CHANGE NOTIFICATION

PCN# 110215

Subject: Notification of Change to LTC4217

LTC4217 Leadframe Design Improvement

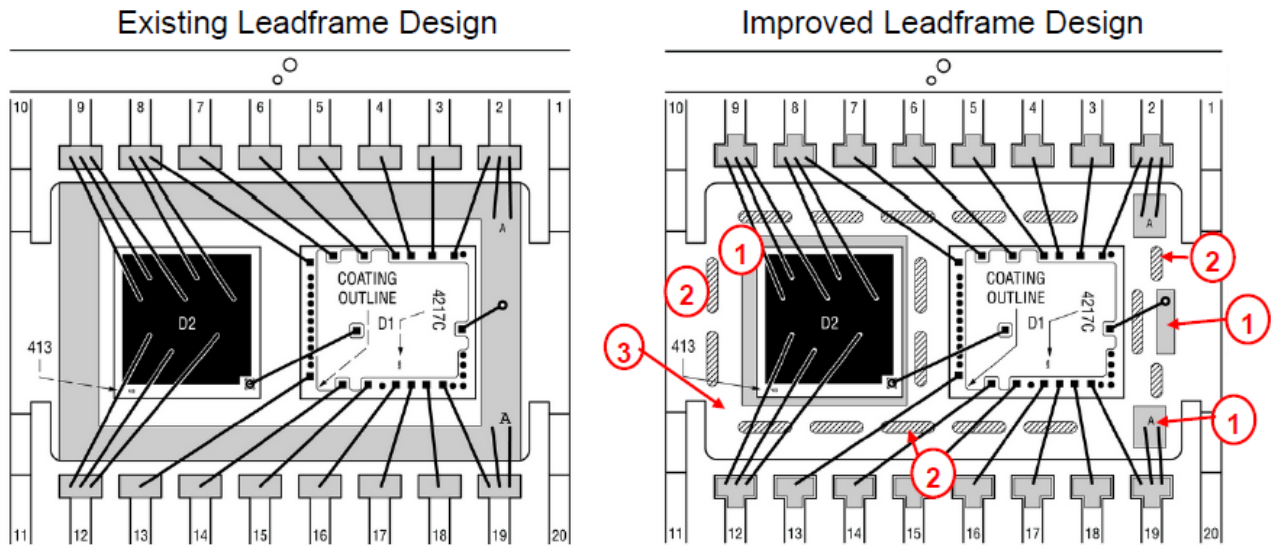
The change includes adding an array of slot holes along the edge of the die attach paddle as mold locking feature to enhance mold adhesion mechanism to the lead frames. In addition to facilitate improvement in our manufacturing yield, a minor change was done to the datasheet as shown on the attached page of the marked up datasheet. The improved product with approximate date code of 1601 will be tested to the new limits.

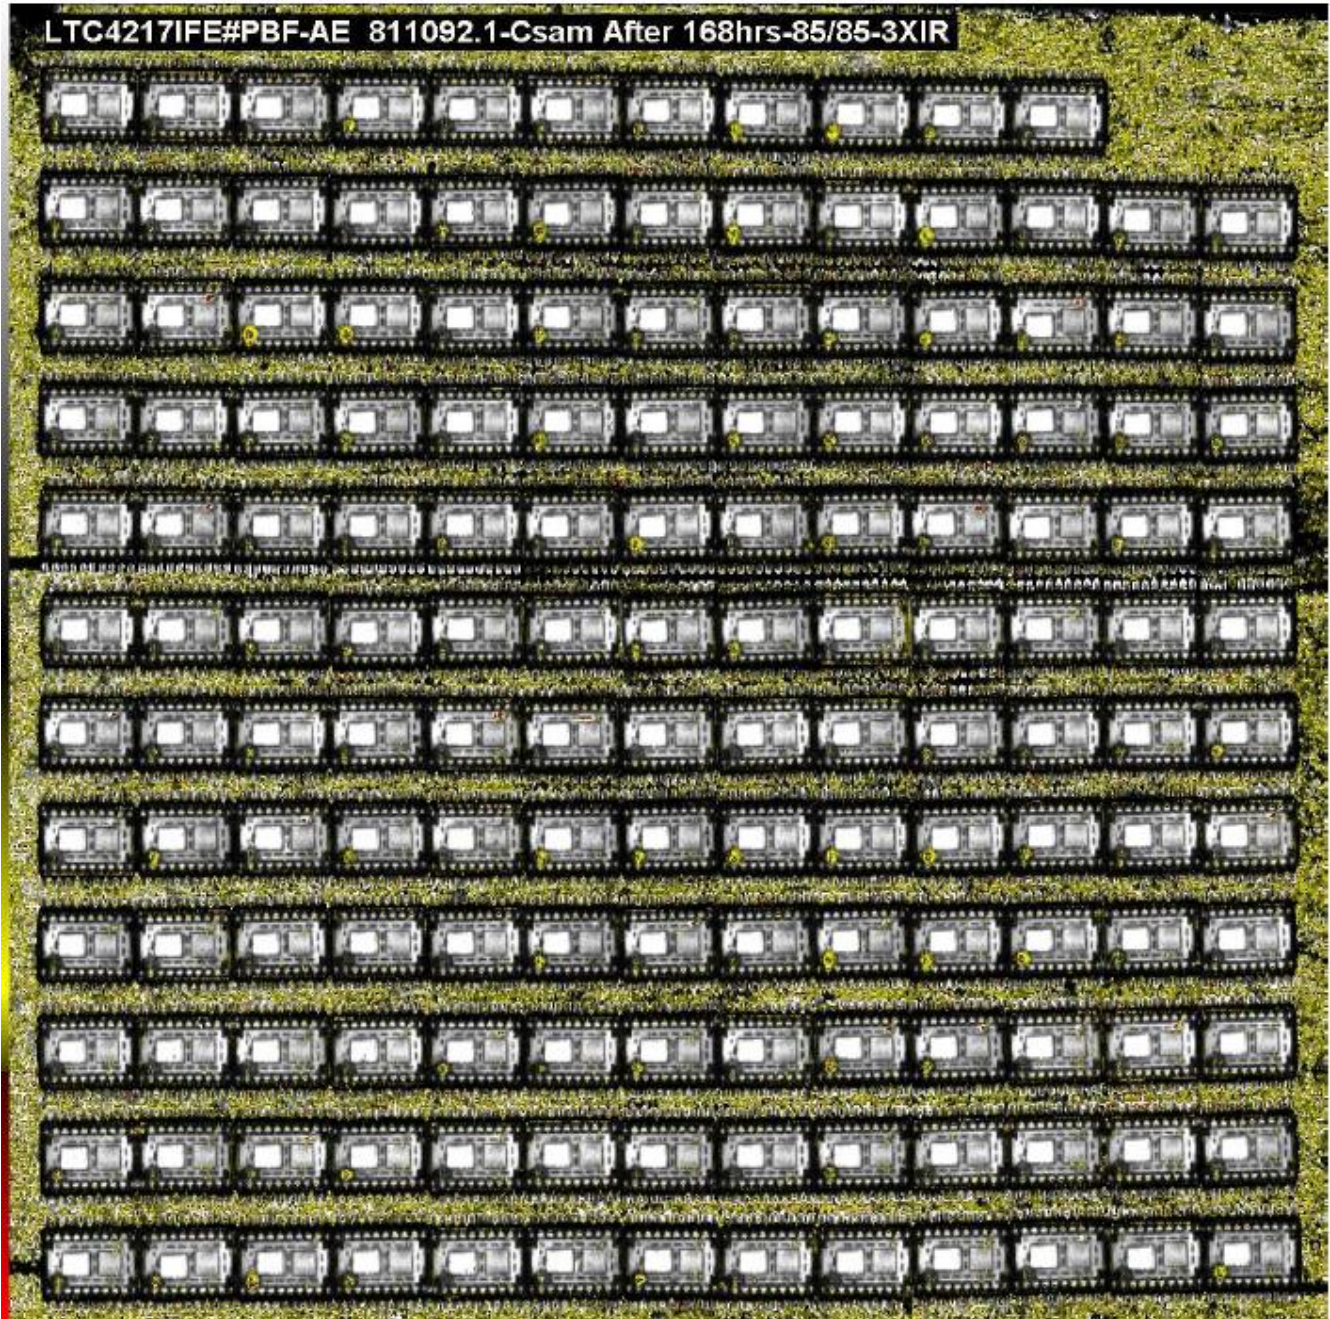
1. Silver ring is replaced by spot silver on areas under FET die (D2), and for Rsense and down bond bonding to improve adhesion.
2. Half etched slots are added on the peripheral of die pad and between dies to enhance adhesion.
3. Brown oxide is added to die pad surface other than spot Ag areas to improve adhesion.
